World Forum for Harmonization of Vehicle Regulations

Working Party on Noise

Report of the Working Party on Noise on its seventy-second session

Annex 3, Figure, amend to read:

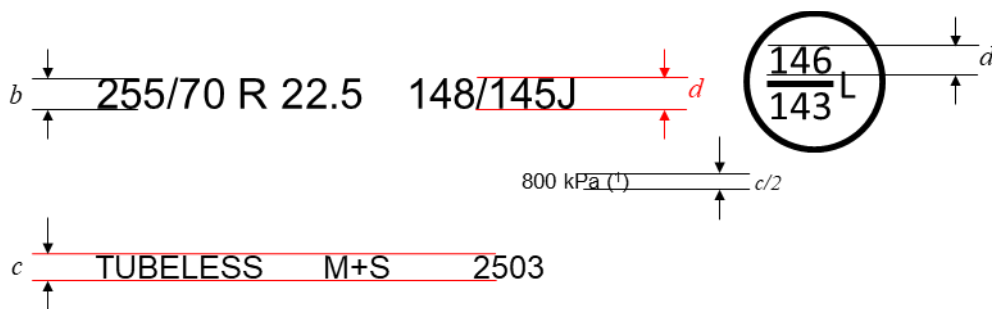
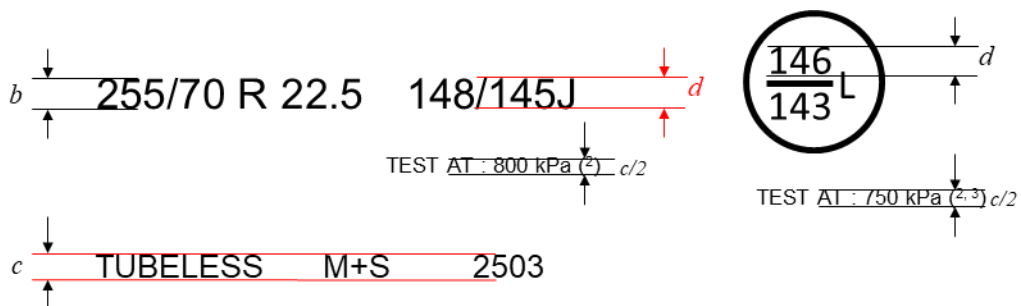
"Example 1:

(1) PSI marking instead of kPa is allowed for tyres first type approved before 1 January 2018. The kPa marking may be preceded by "TEST AT : " or, alternatively, by "TEST INFL : " or the symbol "@".

Example 2:

(2) "TEST AT : " may be replaced by "TEST INFL : " or the symbol "@ " or be omitted.

(3) The indication of a second inflation pressure for the additional service description is optional. If there is no indication, the same test inflation applies to both load/speed combinations.
